2.2 NEARBY INDUSTRIAL, TRANSPORTATION, AND MILITARY FACILITIES

**SOUTH TEXAS PROJECT
UNITS 1 & 2**

OPGP05-ZN-0004	Rev. 1	
Changes to Licensing Basis Documents and Amendments to the Operating License			
CN-1979	Licensing Document Change Request	Page 53	of ____

Figure 2.2-1 0198 Revision 0

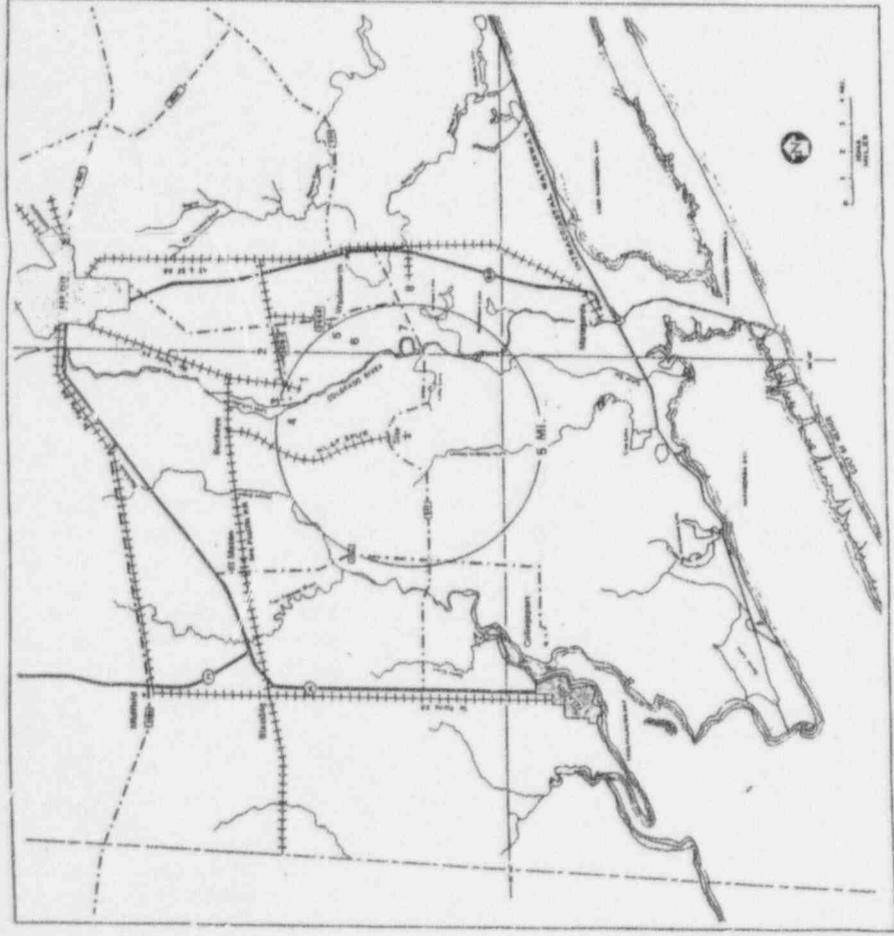
2.2.2.1 Description of Facilities. The five offsite industrial facilities located within approximately 7 miles of the STPEGS are indicated on Figure 2.2-1. | 2

Figure 6.4-1 Revision 2

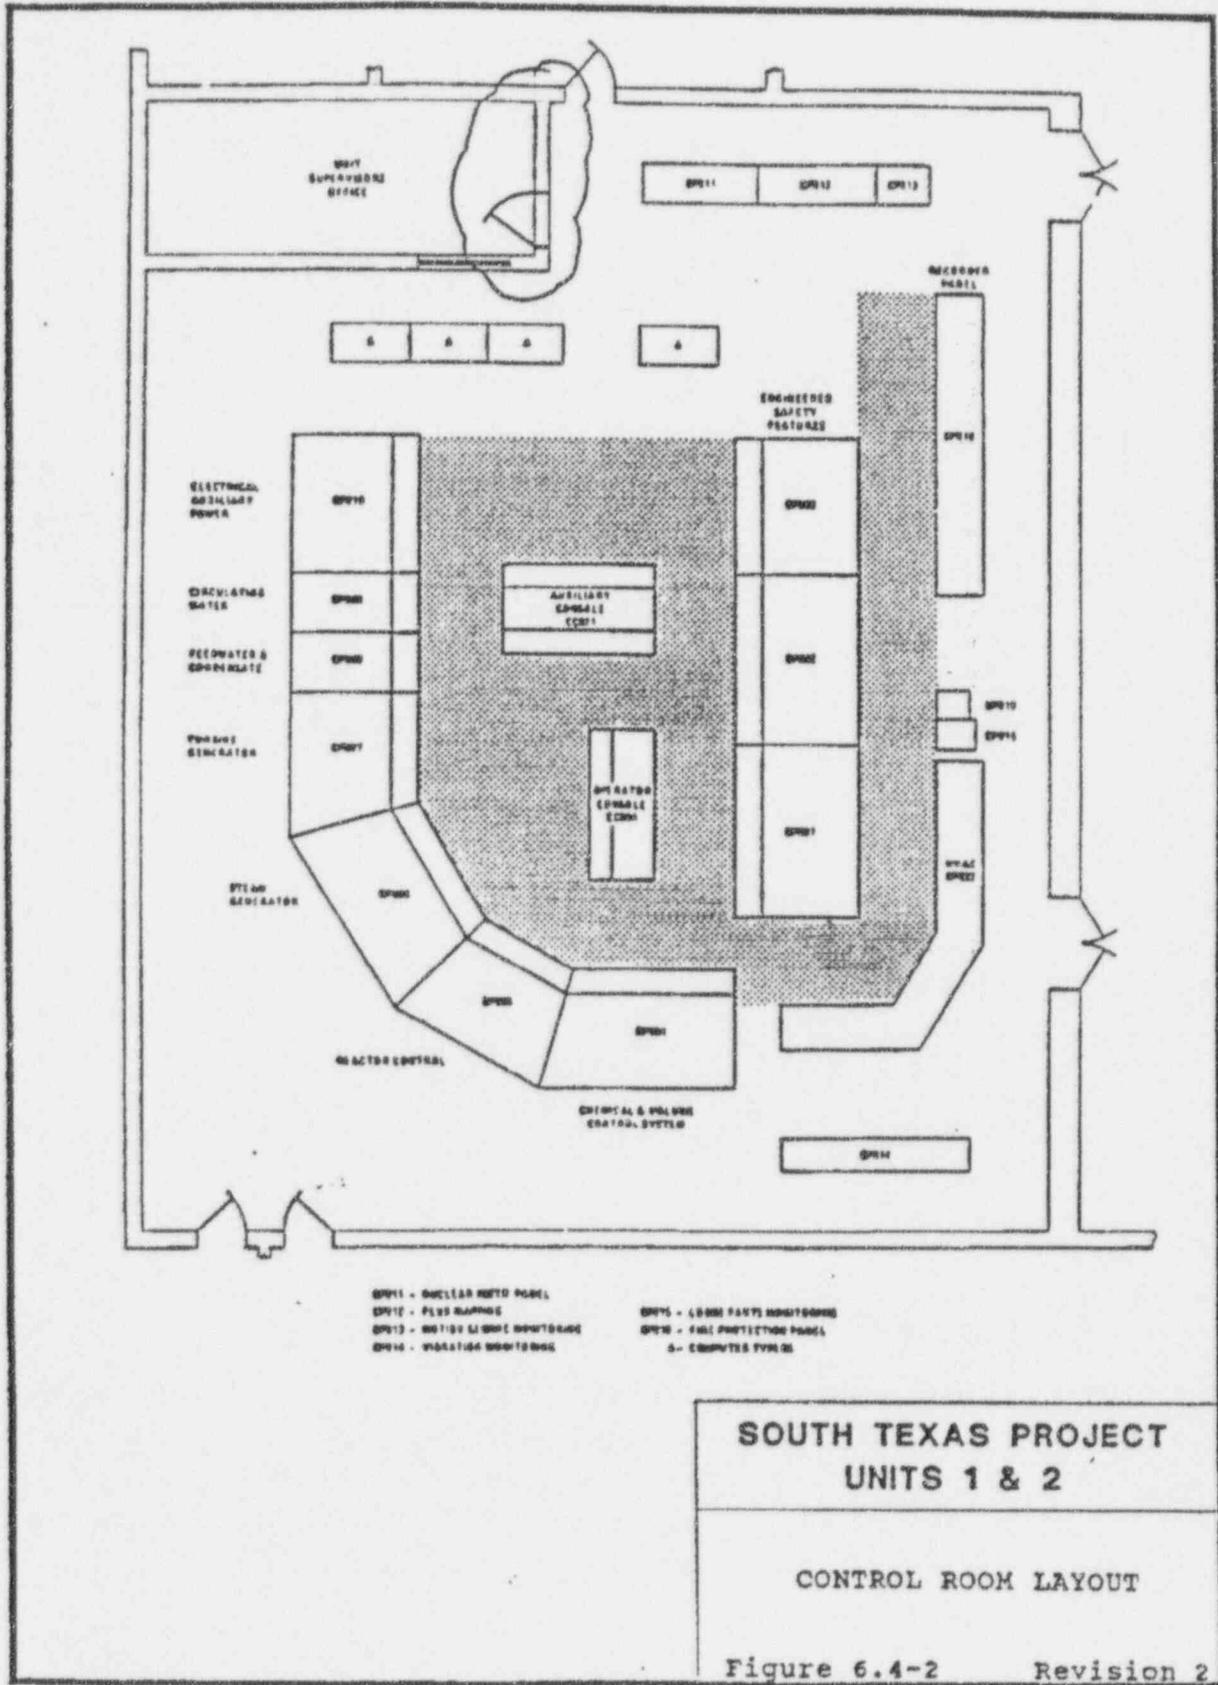
6.4.1.1 Control Room Envelope. The control room envelope is located at El. 35 ft and in two heating, ventilating, and air conditioning (HVAC) rooms at El. 10 ft and 60 ft. in the Electrical Auxiliary Building (EAB) as shown in Figure 6.4-1.
